# REGIONAL REVIEW NOTIFICATION

**ARC REVIEW CODE:** R1902051

**Name of Proposal:** 75 South Logistics Center (DRI 2867)

DRI SITE PLAN  
75 SOUTH LOGISTICS CENTER  
CITY OF LOCUST GROVE, HENRY COUNTY, GA  
JANUARY 16, 2019

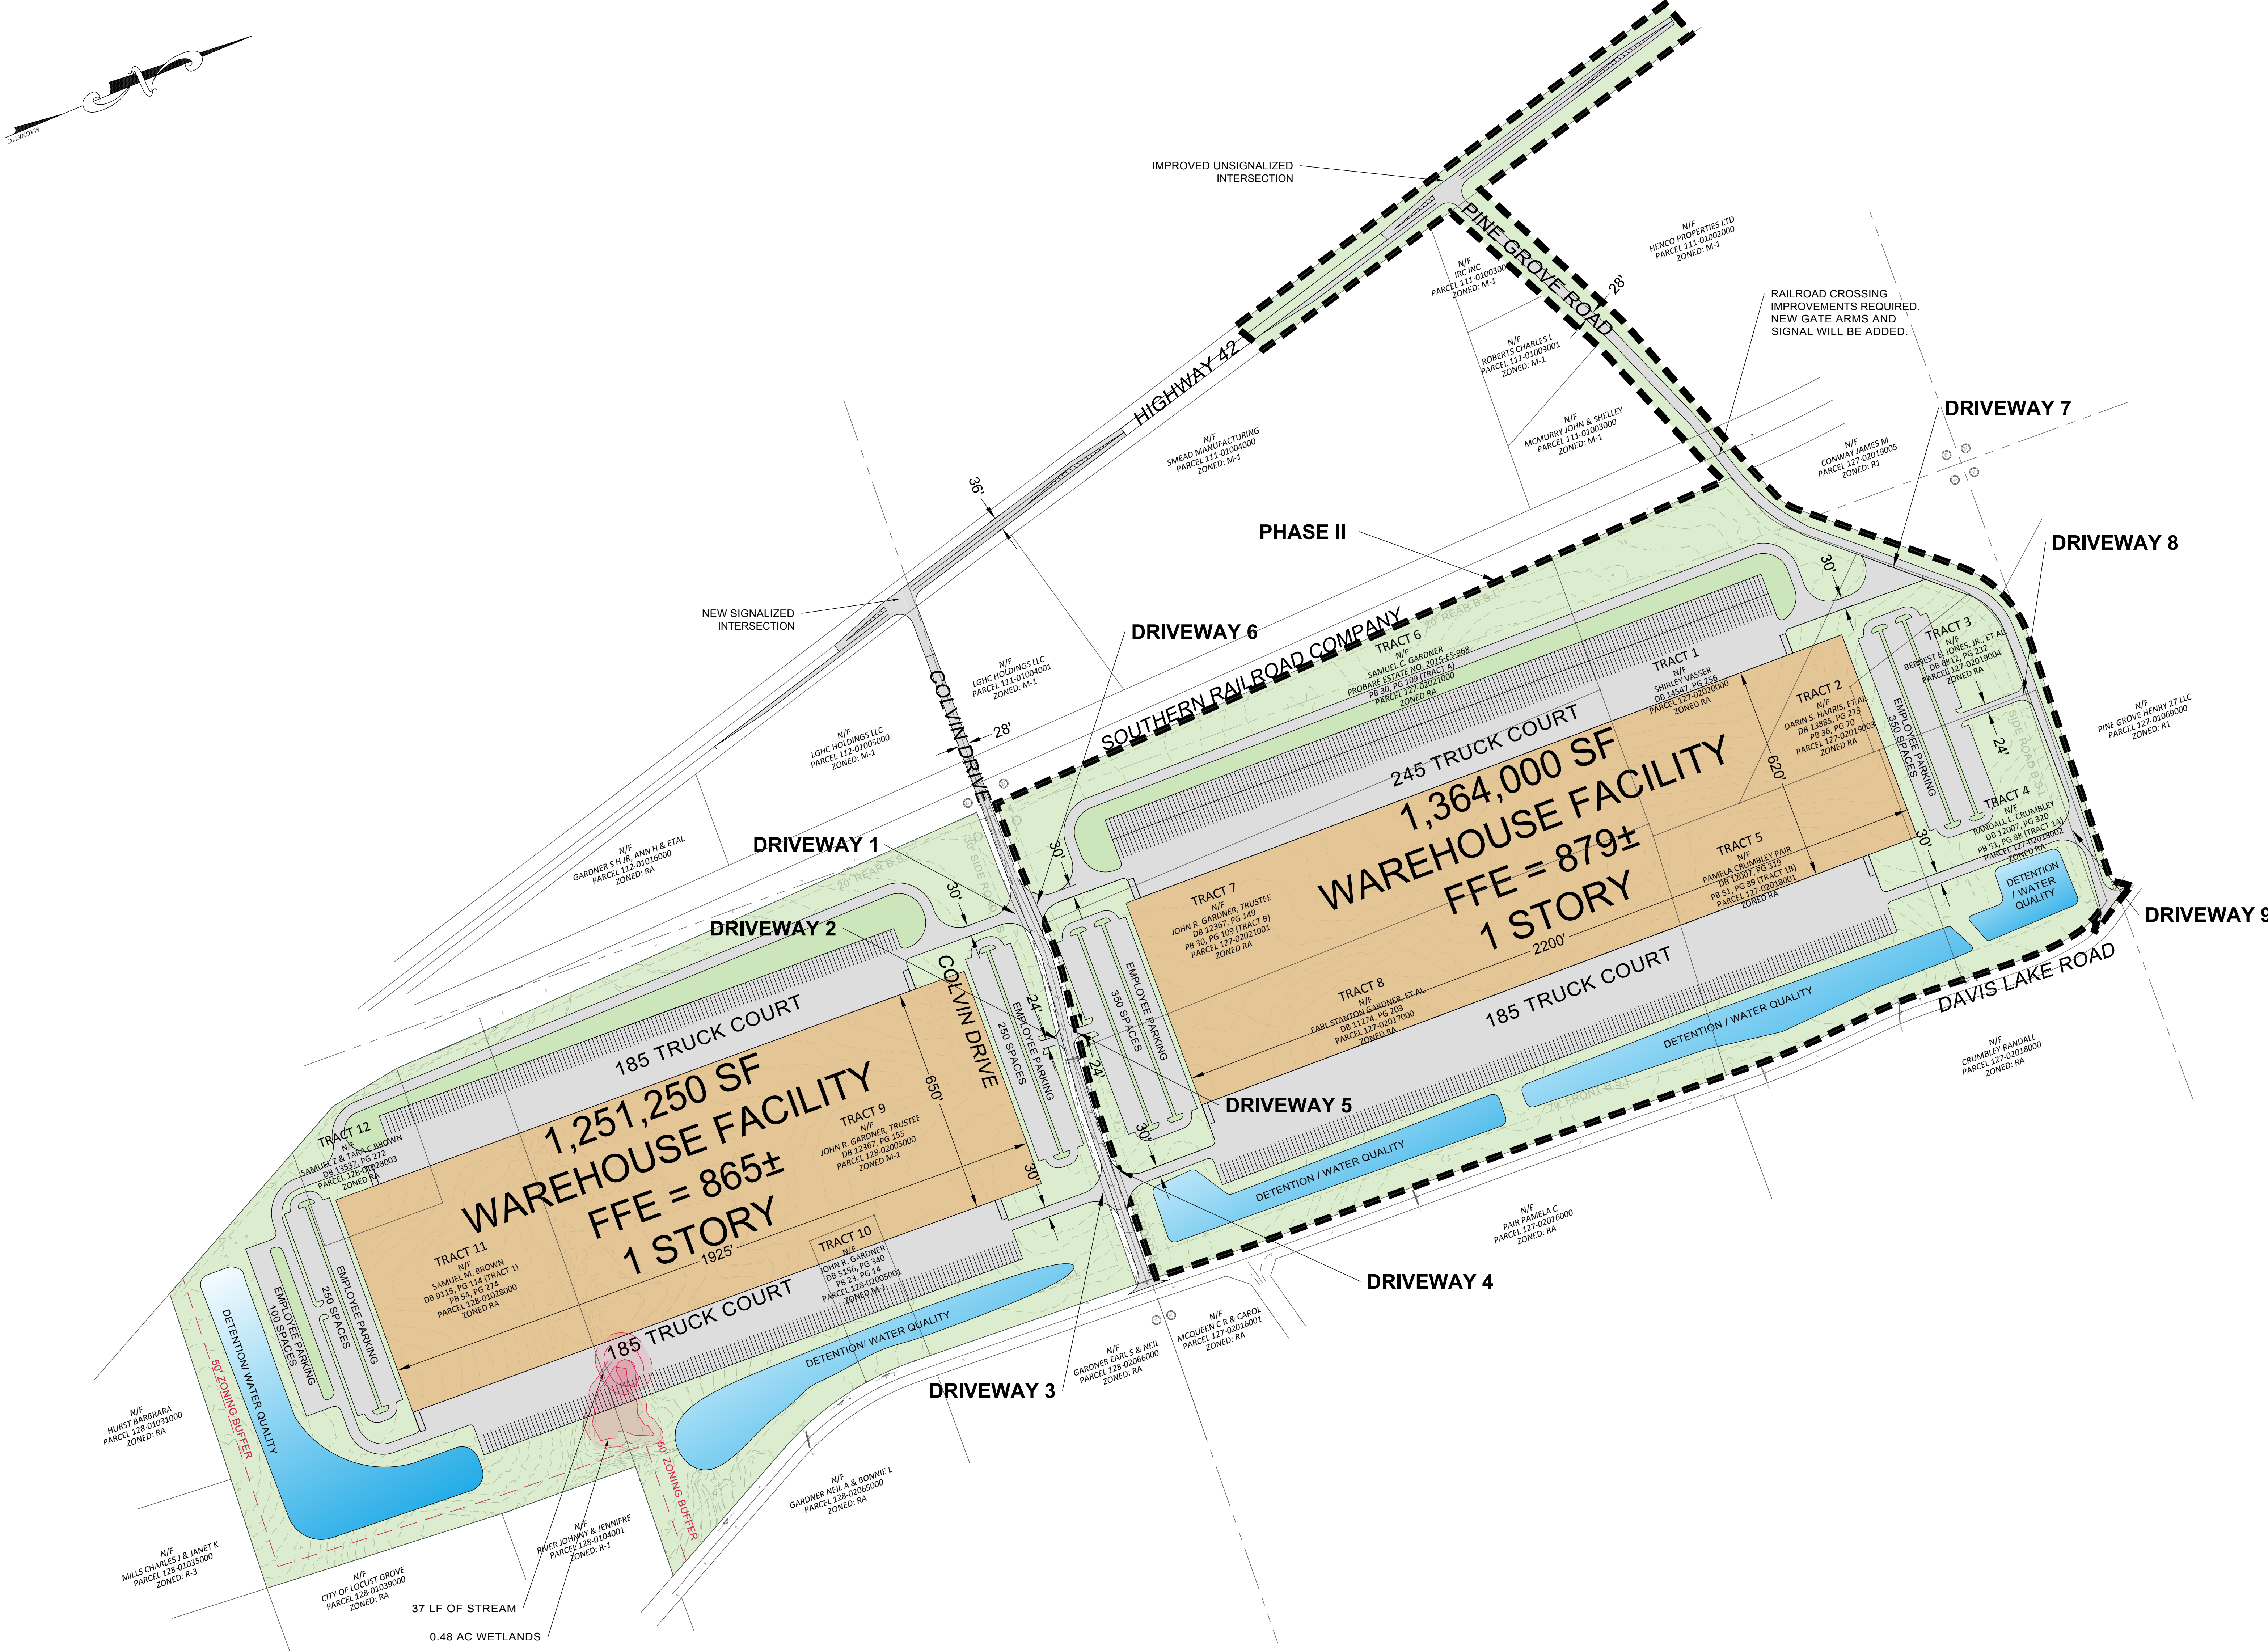
In addition, the development team should ensure that Pine Grove Road is improved to accommodate the DRI project traffic, especially trucks, as shown on the submitted site plan. These improvements also include upgrades – at minimum, a new signal and gate arms – to the railroad crossing on Pine Grove Road. Finally, the development team, City and GDOT will need to continue coordination going forward regarding the planned improvements, shown on the site plan, to the intersections of SR 42 at Colvin Dr. and SR 42 and Pine Grove Rd.

Neither the USGS coverage for the project area or the submitted site plan shows any perennial or intermittent streams on the property. Any unmapped streams on the property may be subject to the Locust Grove Stream Buffer Ordinance as well as the 25-foot State Erosion and Sedimentation Act buffer. Any other waters of the state on the property would be subject to the 25-foot State Erosion and Sedimentation Act buffer.

The project proposes 6 drive access points, 3 on Colvin Drive and 3 on Pine Grove Road. Both are local roads.

Access points are shared by freight and automobile traffic
